ADDENDUM NO. 2

Re: Bedford CSD  
Phase 1B – Bond Improvements  
Fox Lane High School  
SED No. 66-01-02-06-0-003-022  
Fox Lane Middle School  
SED No. 66-01-02-06-0-007-012  
Mount Kisco Elementary School  
SED No. 66-01-02-06-0-006-016  
Bedford Hills Elementary School  
SED No. 66-01-02-06-0-004-021  
Our File No. 22-225

Addendum No. 2 – Bedford CSD Phase 1B Bond Improvements at the Fox Lane High School, Fox Lane Middle School, Mount Kisco Elementary School, and Bedford Hills Elementary.

M2.03

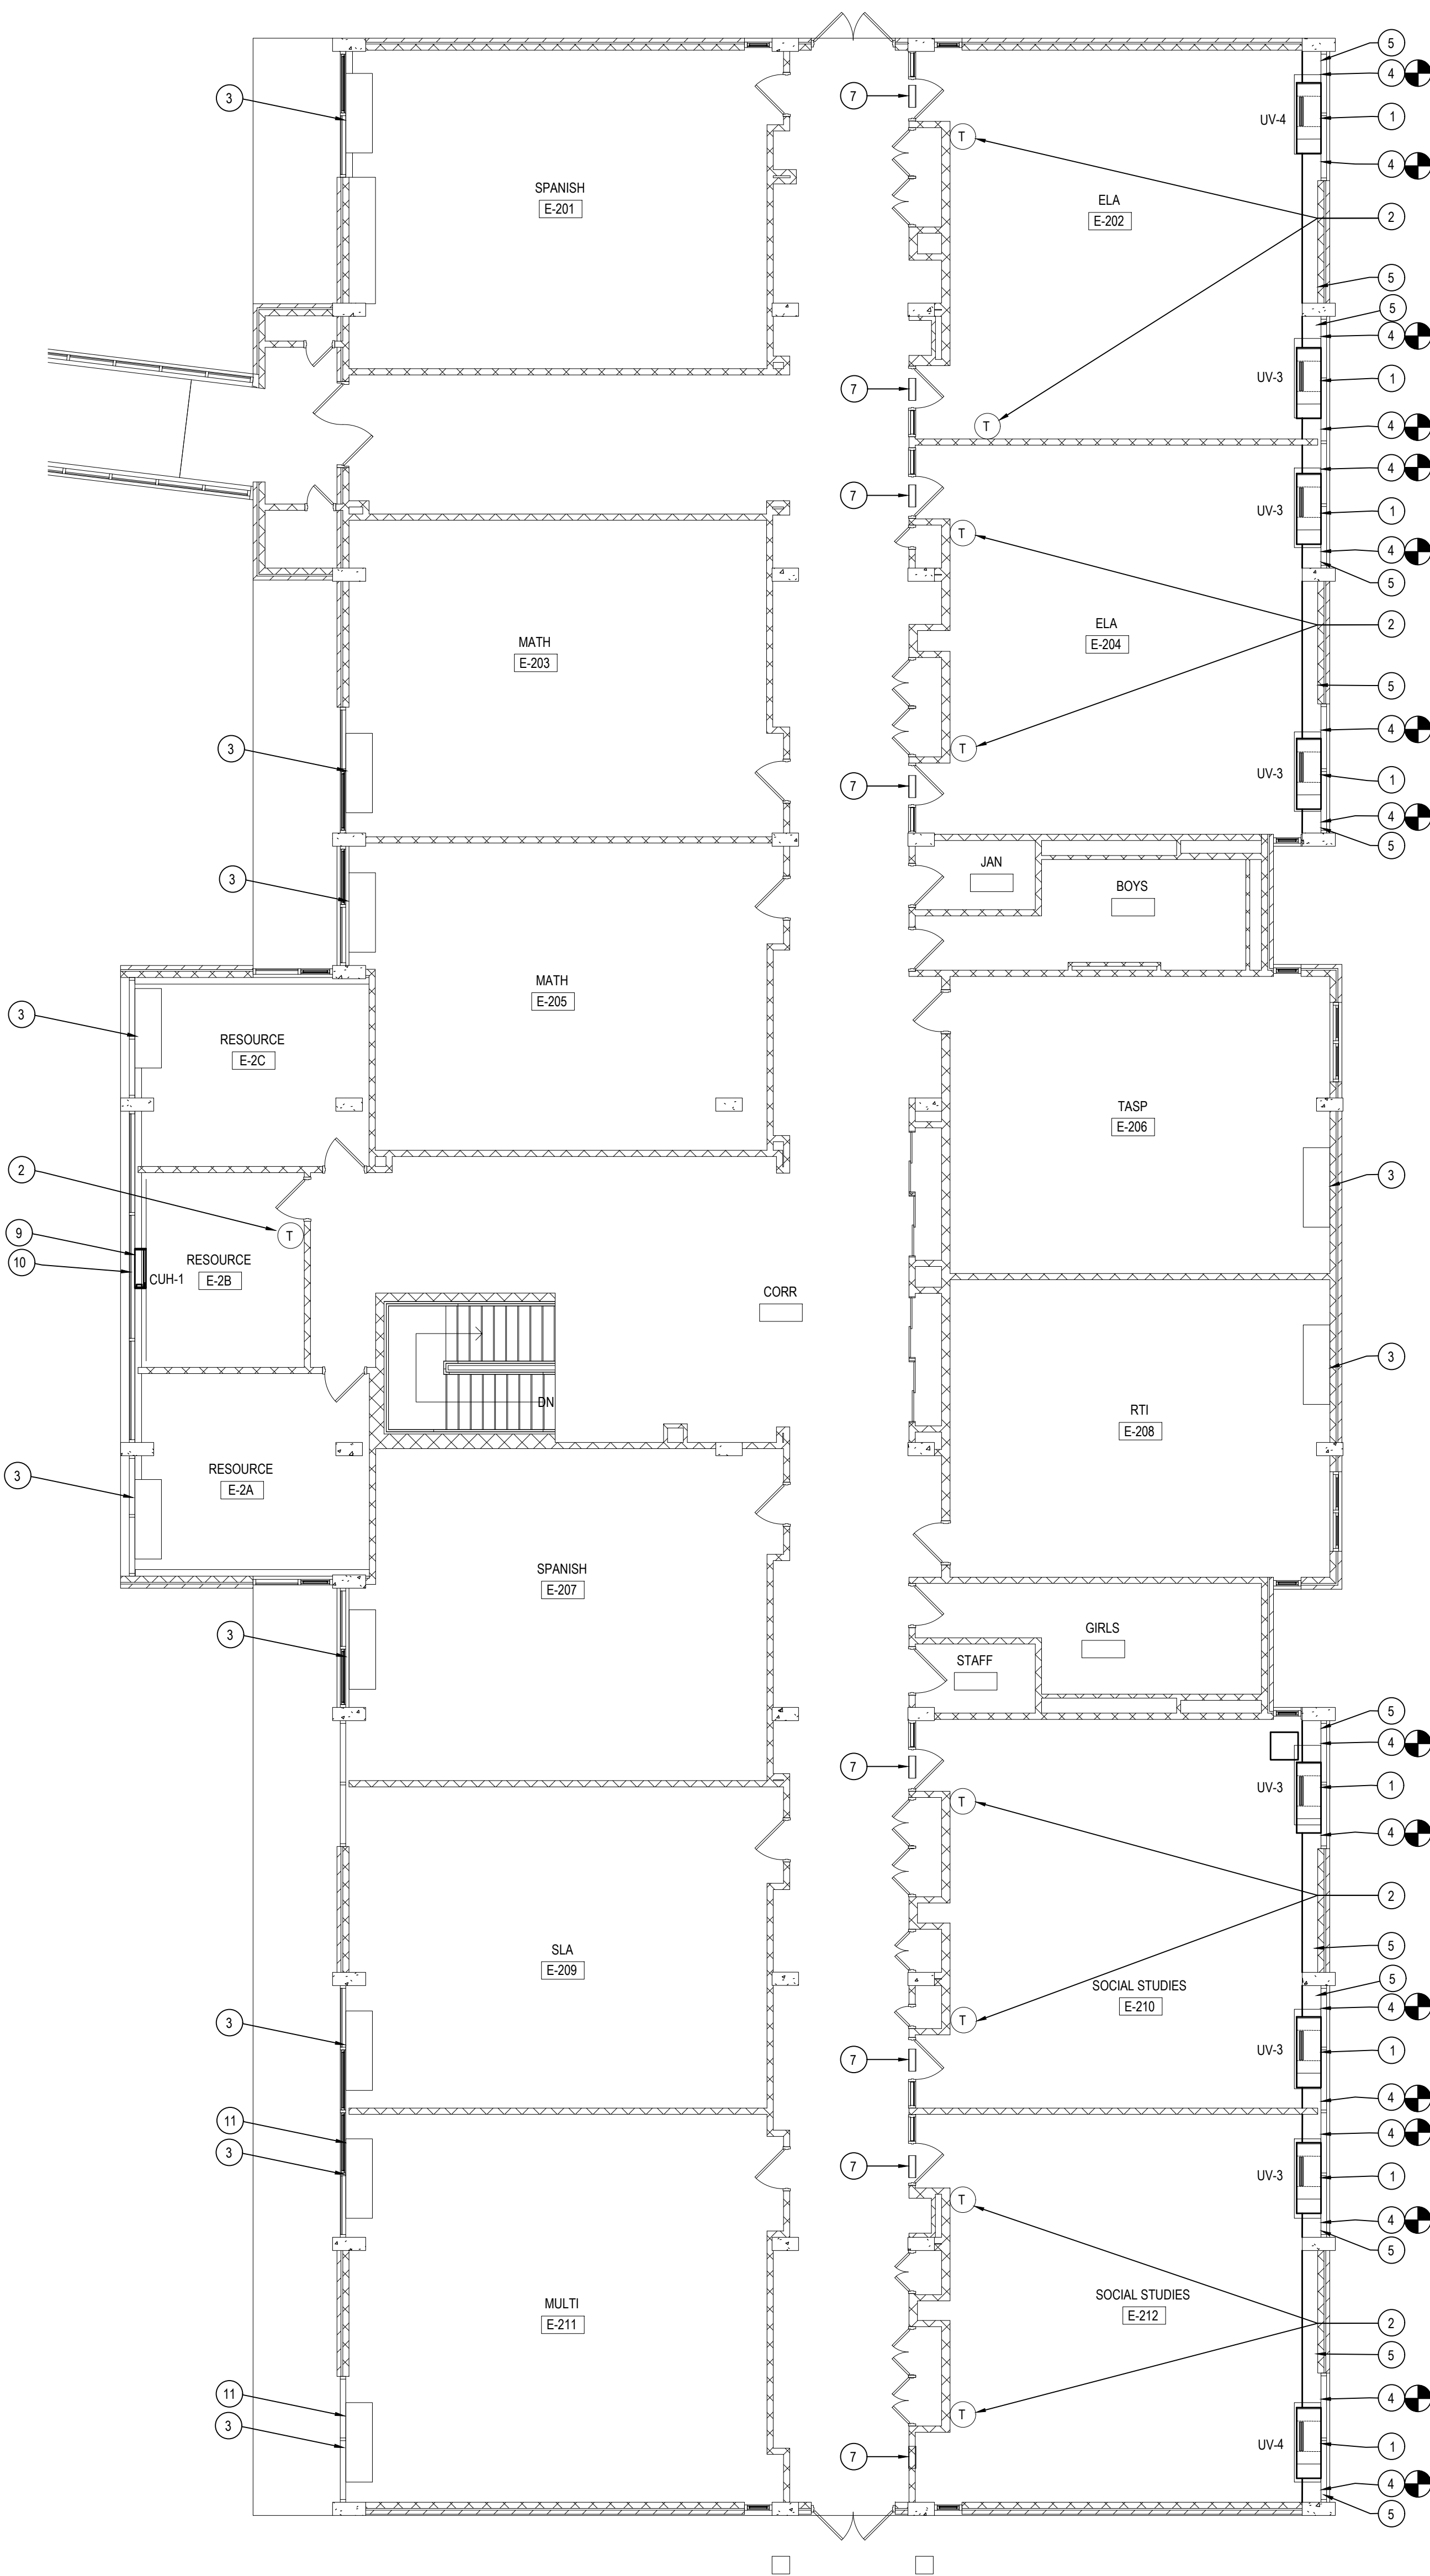
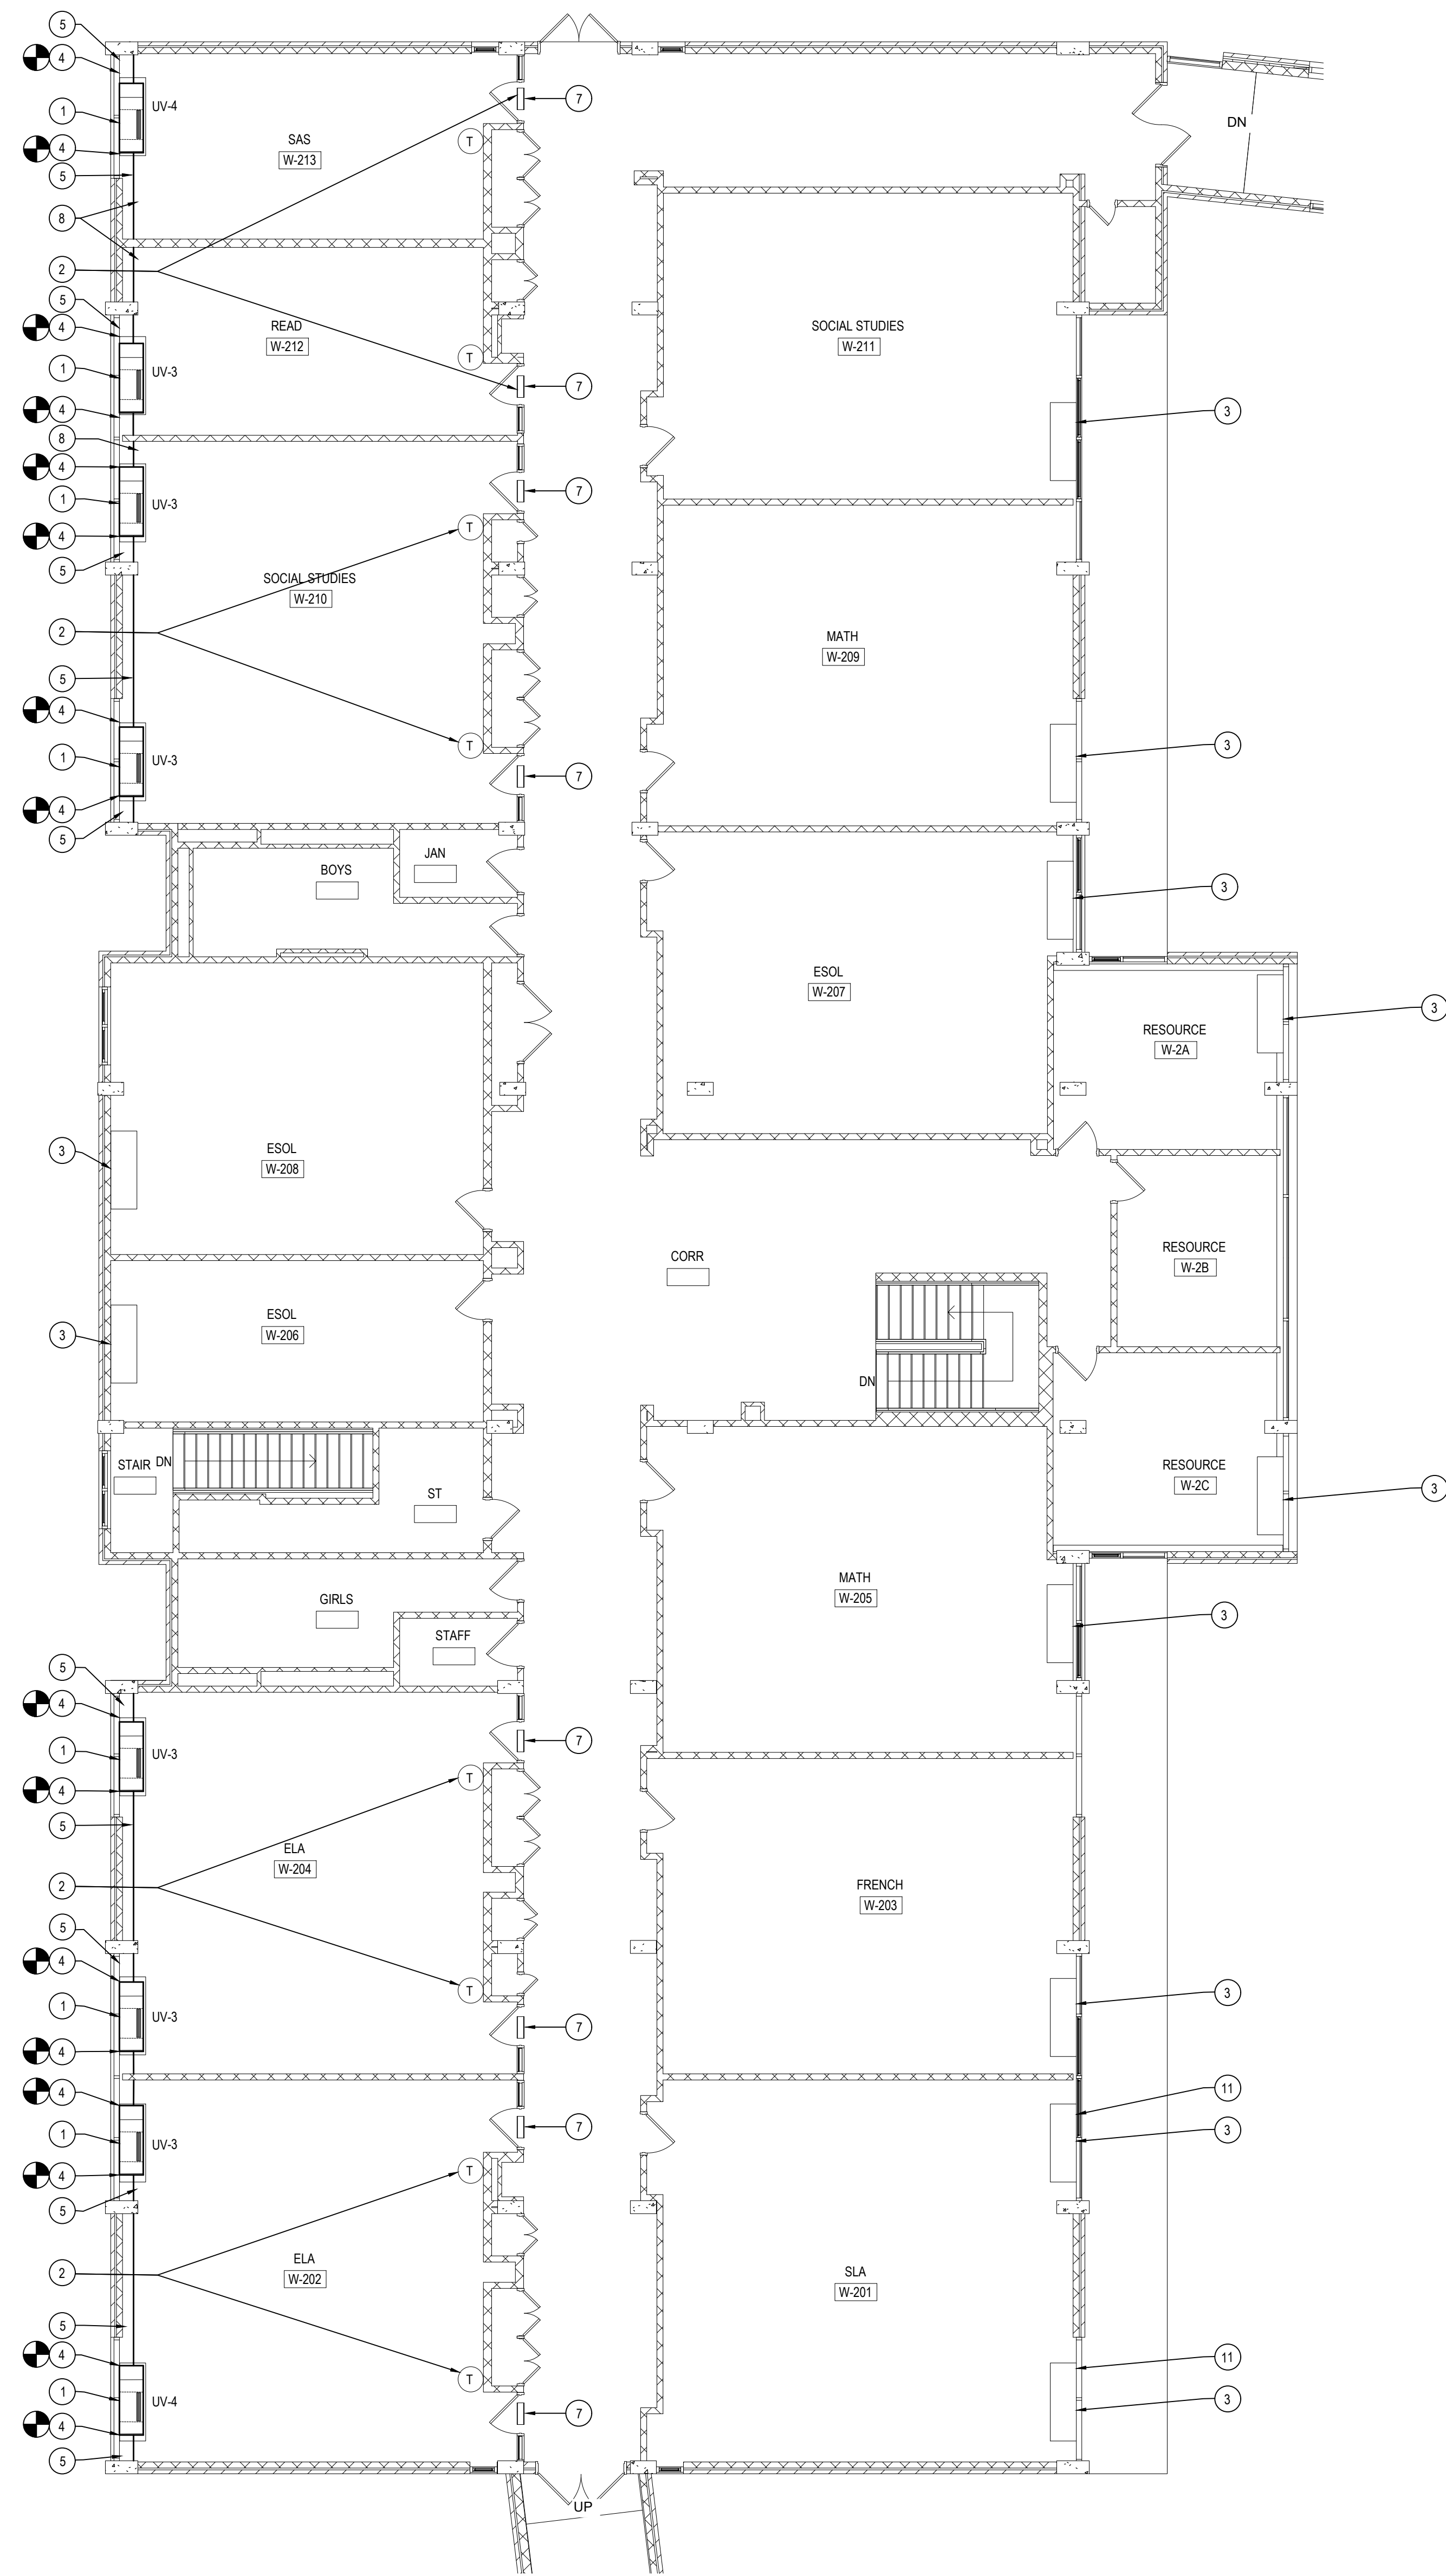
1. Drawing M2.03 – Fox Lane Middle School – New Mechanical Plan, Second Floor East House and West House
  - a. The drawing attached to this Addendum shall replace the one within the Bid Documents.
2. Drawing M2.04 – Fox Lane Middle School – New Mechanical Plan, Second Floor South House
  - a. The drawing attached to this Addendum shall replace the one within the Bid Documents.

4. Comment - On Fox lane drawings M2.03 & M2.04, note 3 shows existing UV's to remain and for the MC to trim FTR and provide end caps. No work is shown in these areas. Why does the MC need to trim the FTR and provide end caps? Please advise.

Response - Please be advised that this is addressed in Addendum No. 2. Read Construction Drawing Modifications.

**22-225L BEDFORD HILLS E.S.**  
**BOILER BLEND PUMP DETAIL**  
 (REFERENCE PROJECT RFI-03)

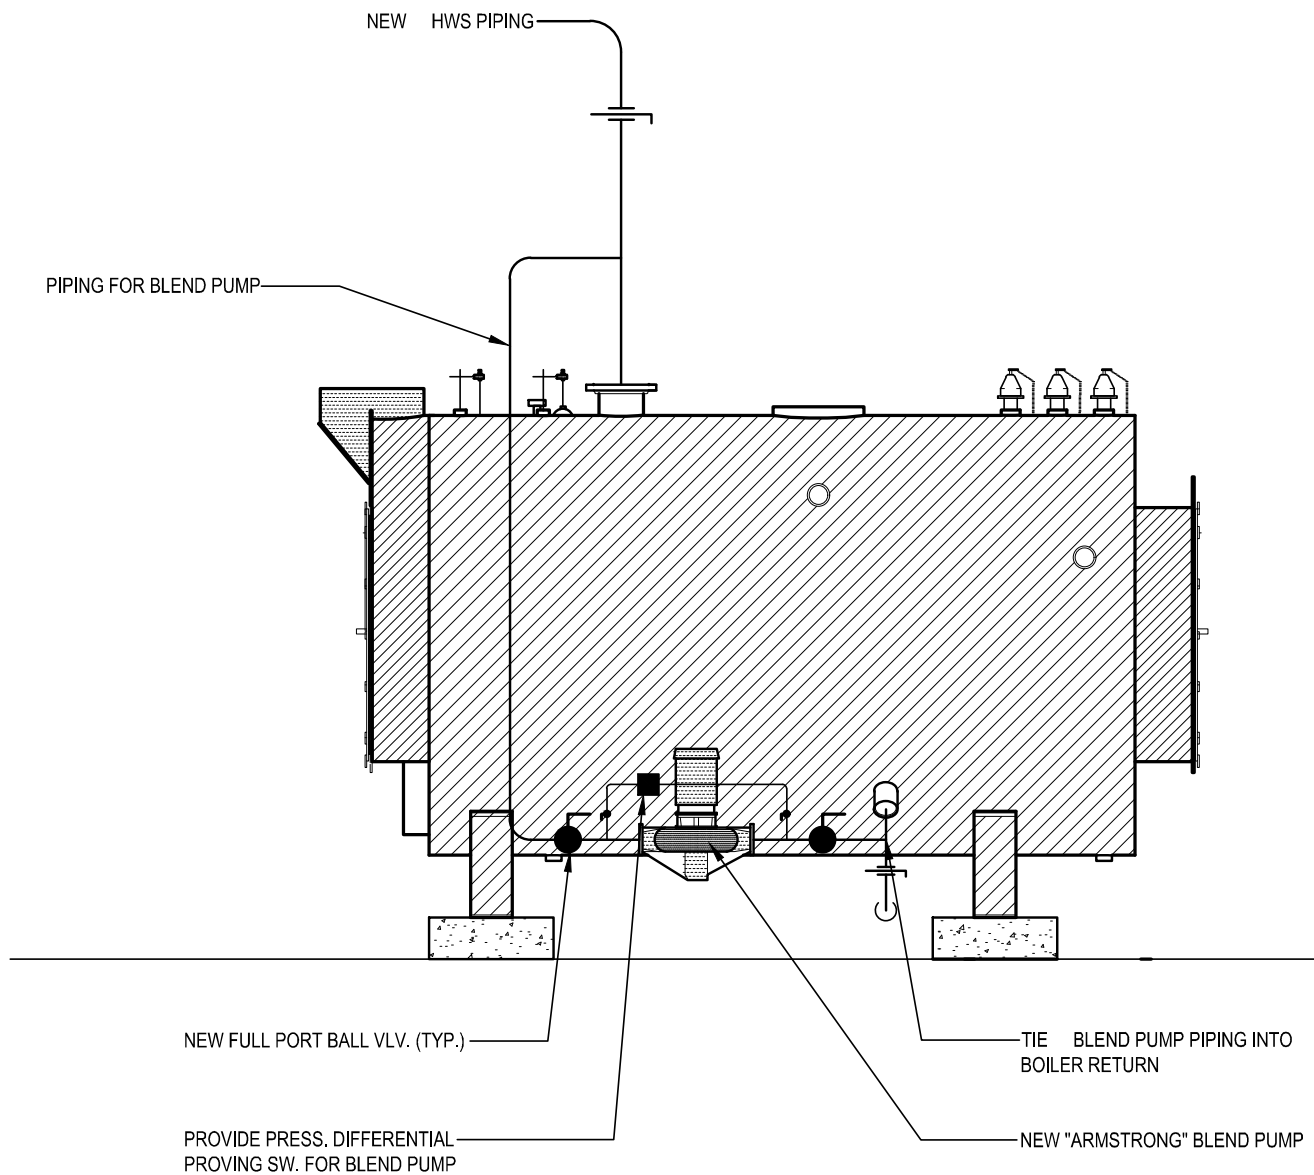
7. Comment - Please provide detailed drawing showing where the pump is to be installed along w/other accessories if needed.

Response - Just loop it between the boiler outlet (supply) and the boiler inlet (return). See attachment.
